LADACAN Response to RNAV1 consultation

NAME: John Davis (on behalf of LADACAN)

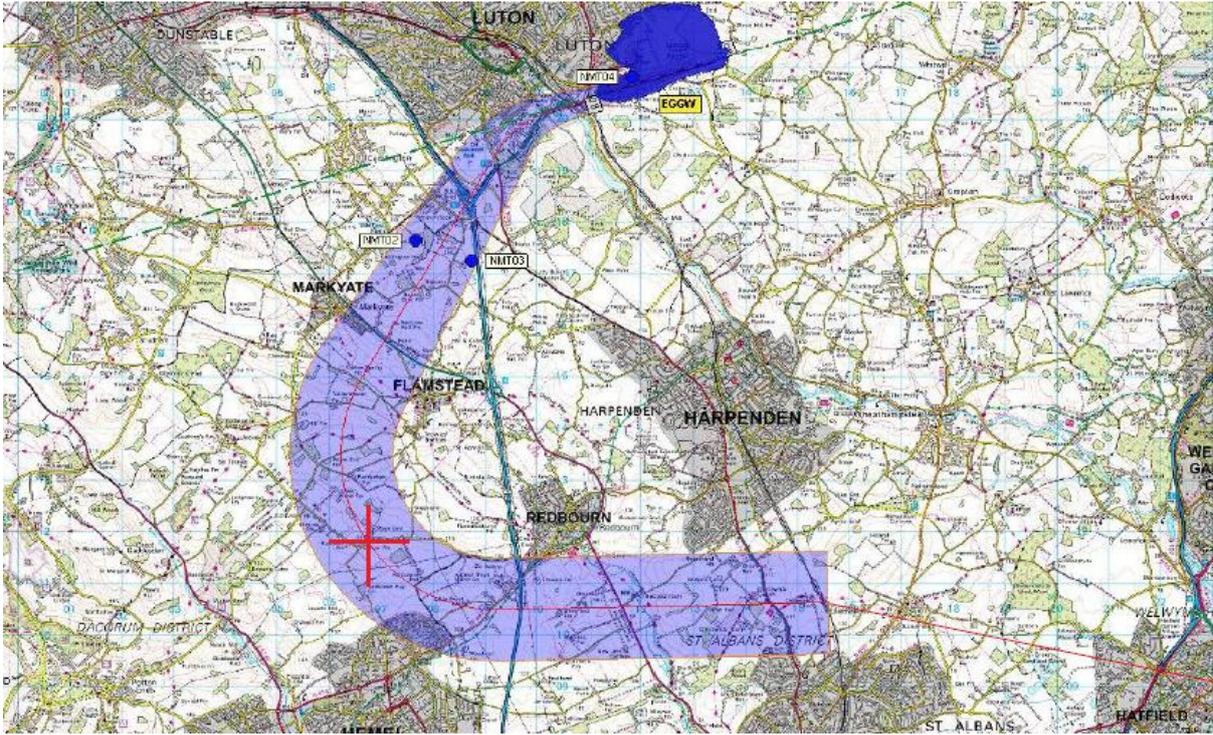
The proposal to raise the vectoring altitude from 3,000 to 4,000 feet AMSL is welcome to a degree but with most aircraft already above 4,000 ft by Redbourn, that of itself would not prevent vectoring away from the centreline over S. Harpenden or N. St Albans. We would therefore expect Swanwick to abide by the CAA's 7,000 ft 'advisory' that aircraft should avoid overflying communities as far as possible, by keeping them on the centreline until East of the railway line. This would be in line with Government policy to avoid centres of population where possible though with its obvious disadvantage to rural residents who, with lower background noise levels, are more likely to notice aircraft going over.

Position of SW extreme of SID centre line

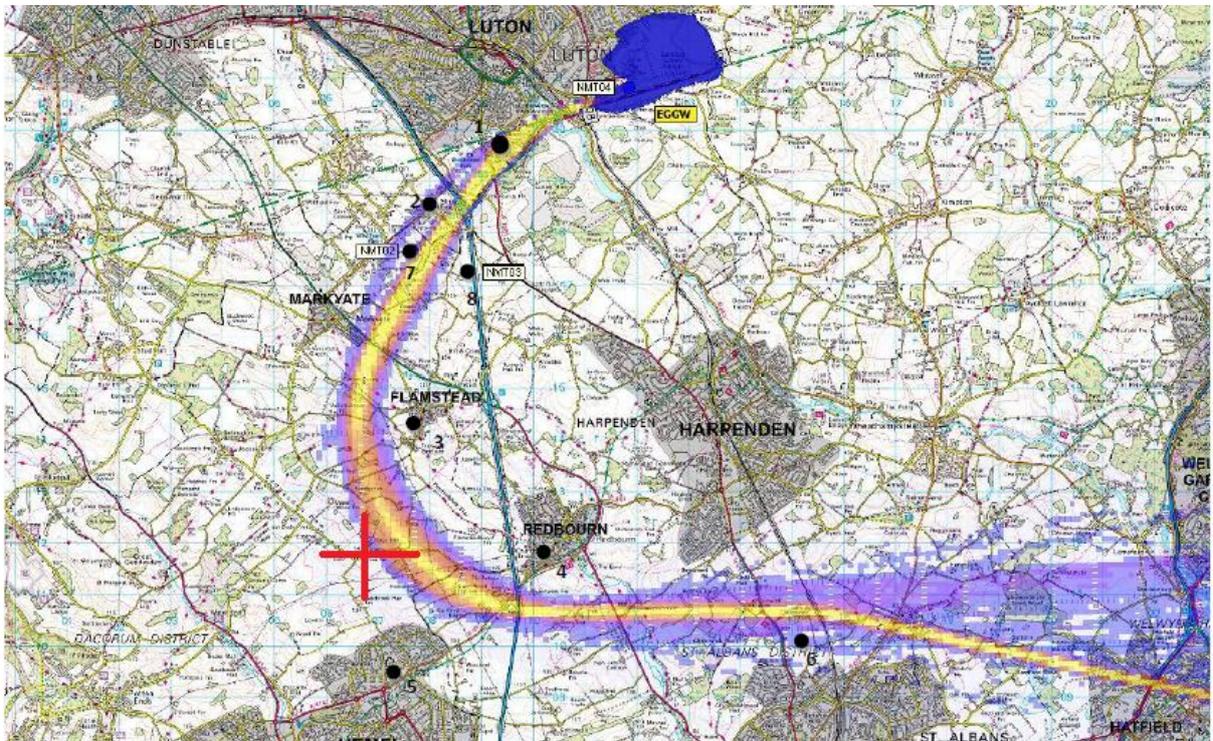
- that all aircraft should adhere to the centreline on the Southwesterly sector following the first turn and not steer N. of it (perhaps in preparation for the 2nd turn?) and that the 2nd turn shouldn't commence until *after crossing the A5* whereas the above-mentioned 5/5/13 tracks showed some aircraft N. of the centreline at that point [hence over S. Markyate] &/or *starting the turn early* [hence closer to Flamstead than 'should' be]. Also almost all were '*inside*' the prescribed centreline on the section W. of Redbourn (see maps at end);

Proof that aircraft paths are not distributed around the centre line W of Redbourn: all are inside it
